**TOWN OF BENNETT, COLORADO
PLANNING & ZONING COMMISSION
Regular Meeting
June 28, 2021**

A. Case No. 21.10 – Bennett Ranch Phase 2 Single-Family Detached Sketch Plan

B. Case No. 21.12 – Bennett Ranch North R-3 Townhome Sketch Plan

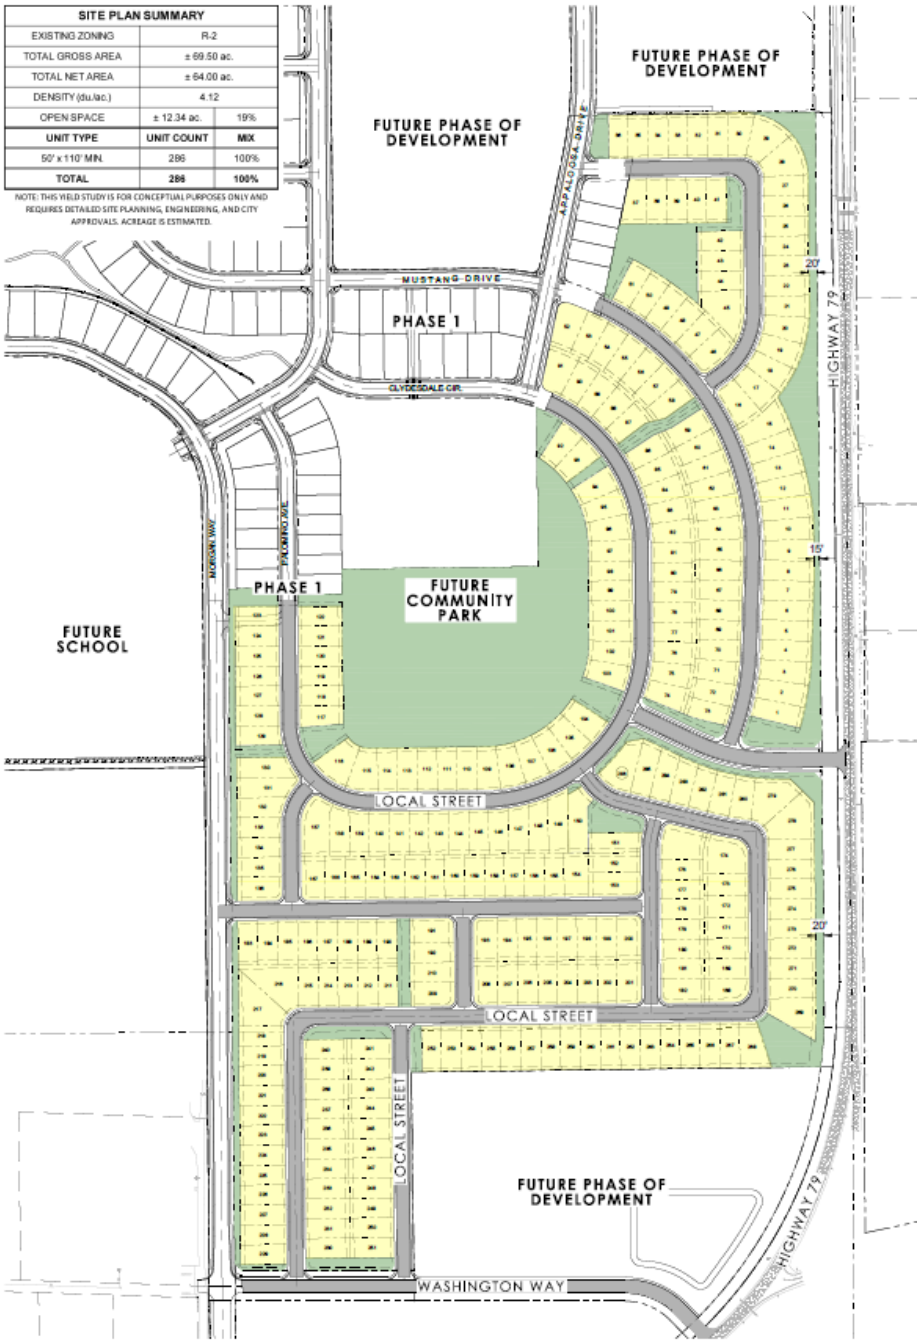
Minimum lot sizes are 5,500 square feet, consistent with the R-2 - Mid Density zoning district. The sketch plan also shows an expansion of the future community park that was created by Filing 1.

Staff Response: The proposed residential subdivision is consistent with the R-2 zoning and the Comprehensive Plan.

Staff Response: The sketch plan represents a functional system of land use and complements the lot layout and street network of the Bennett Ranch Phase 1 single-family subdivision.

Staff Response: The Town's water supply, water distribution and sanitary sewer systems will be able to accommodate the proposed development. Adequate access is via Palmer, CO Highway 79 (Kiowa-Bennett Road) and an improved East 38th Avenue.

1. The Town Engineer indicates the Town will have water system capacity, including fire flows, and sanitary sewer collection system capacity to serve the subdivision. Details regarding final water, sanitary sewer and stormwater system design will be addressed at the time of final plat. The Town Engineer also commented on the potential noise impacts and related building setbacks from CO Highway 79. Staff is working with CDOT on the eventual design and necessary right-of-way for the highway. Potential noise impacts and appropriate mitigation will be addressed at the time of final plat.

2. The Town Traffic Engineer commented on the trails and pedestrian paths and the potential need for future pedestrian crosswalks. This will be addressed in more detail with the final plat.

3. Bennett School District 29J will ask for cash-in-lieu of land dedication.
4. Bennett-Watkins Fire Rescue has submitted several comments relative to fire protection, including reference to the International Fire Code (IFC), fire hydrant location and fire flows. These comments have been forwarded to the applicant.

5. The Intermountain Rural Electric Association (IREA) has submitted comments regarding the need for utility easements. These will be placed on the final plat.

Staff Response: Although no negative impacts on adjacent land uses are anticipated, staff will defer a finding on this criterion until we receive and review a more detailed final plat and site plan.

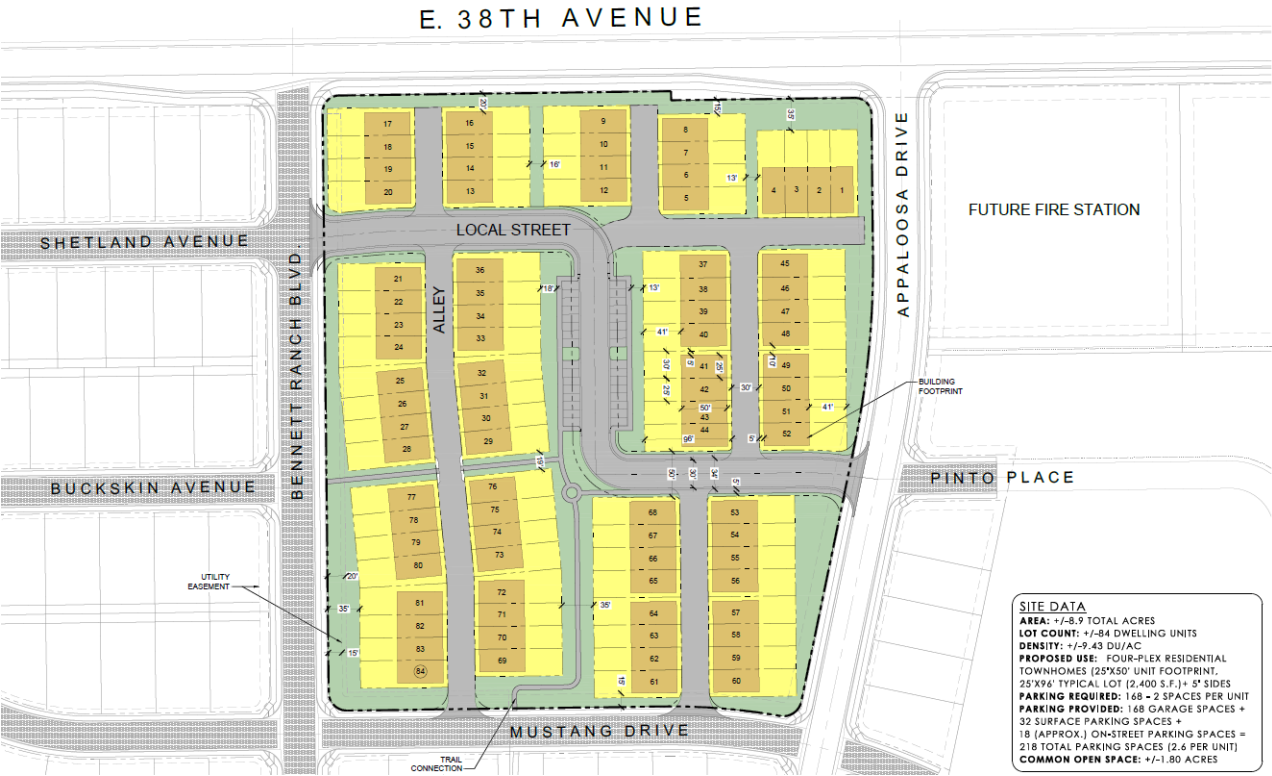
Staff Response: The proposed residential subdivision is consistent with the R-3 zone district and the Comprehensive Plan. The proposed lots sizes of 2,400 sq. ft. and the proposed density of 9.43 dwelling units per acre conform to the R-3 zone district standards.

Staff Response: The sketch plan represents a functional system of land use and is generally consistent with the previously reviewed 2018 Bennett Ranch Sketch Plan.

Staff Response: The Town's water supply, water distribution and sanitary sewer systems will be able to accommodate the proposed development. Adequate access is via future streets approved as part of the Bennett Ranch Filing 1 Final Plat, including an improved East 38th Avenue.

- 8. Confirmation of building footprint sizes and building setbacks will be confirmed at the time of final plat and site plan.
- 9. The Town Engineer indicates the Town will have water system capacity, including fire flows, and sanitary sewer collection system capacity to serve the subdivision. Details regarding final water, sanitary sewer and stormwater system design will be addressed at the time of final plat. In addition, local street radii will need to be confirmed by the Bennett-Watkins Fire Rescue Authority.

- 10. Traffic from this site was accounted for in the 2018 Traffic Impact Study. The Town Traffic Engineer indicated a concern about future on-street parking on the local streets and near the intersections with the alleys. More detail will be required at time of final plat and site plan. In addition, the trail connections and pedestrian crossings of Bennett Ranch Boulevard and Mustang Drive will require appropriate traffic control and pedestrian crosswalks.

12. Bennett-Watkins Fire Rescue (BWFR) recommends the developer confer with the district to ensure the proposed development conforms to adopted International Fire Code (IFC) standards. BWFR's referral response includes, but is not limited to comments on hydrant distribution, fire flows and access. BWFR is requesting the developer provide a modeling exhibit based on fire apparatus design criteria showing adequate widths and turning radii.
